Scoping Comment B3 – Center for Biological Diversity

**Re: Comments on the Proposed Supplemental Environmental Impact Statement
& Supplemental Environmental Impact Report for the Palen Solar PV
Project**

Figure 7. Distribution of major and minor land units on the Palen site. Project boundary shown in gray, proposed solar arrays shown in blue.

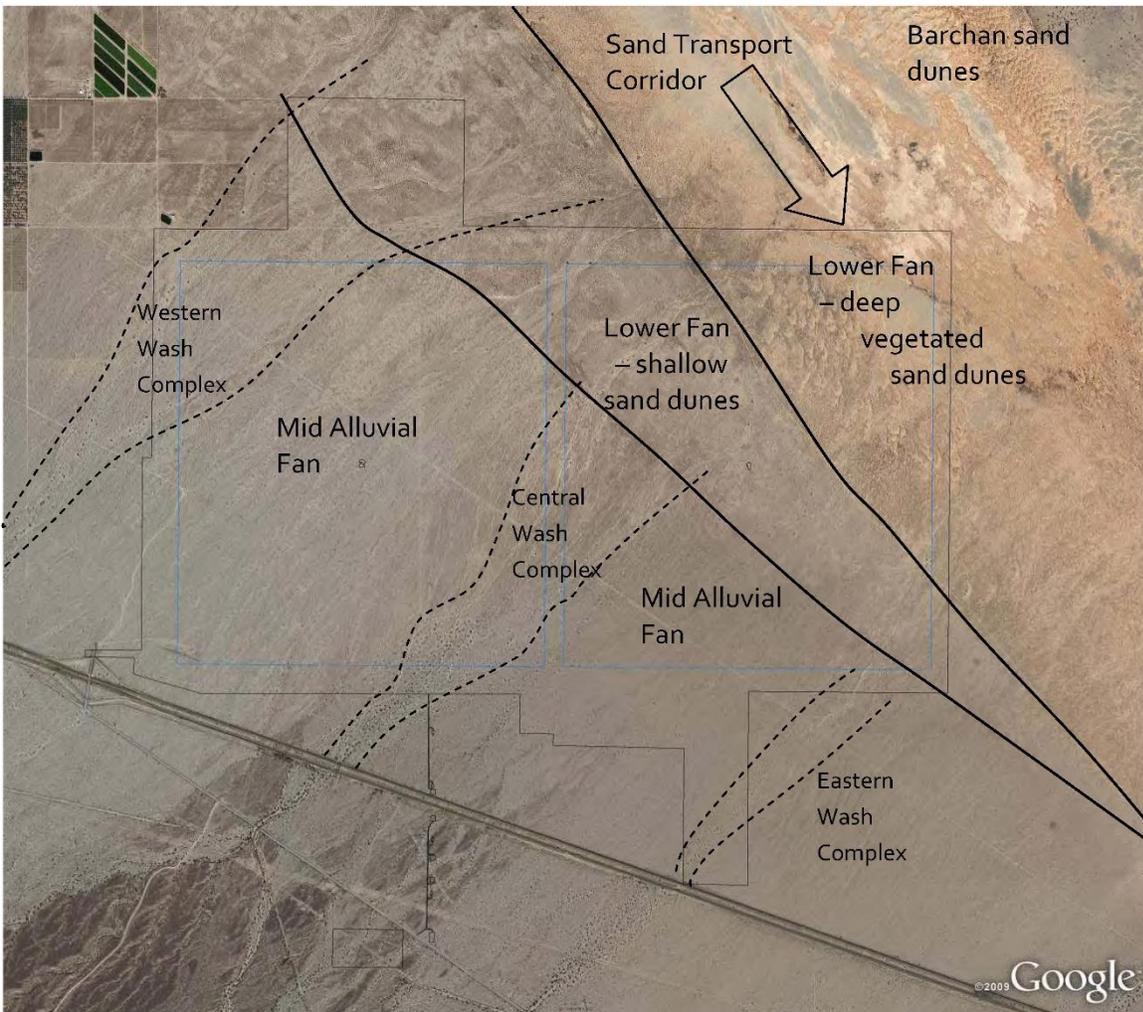
- An alternative configuration that avoids all sand areas and MFTL habitat (as described above) and also avoids all large wash complexes including both the Central wash complex and Western wash complex (figure 7, Collison) must be fully evaluated.
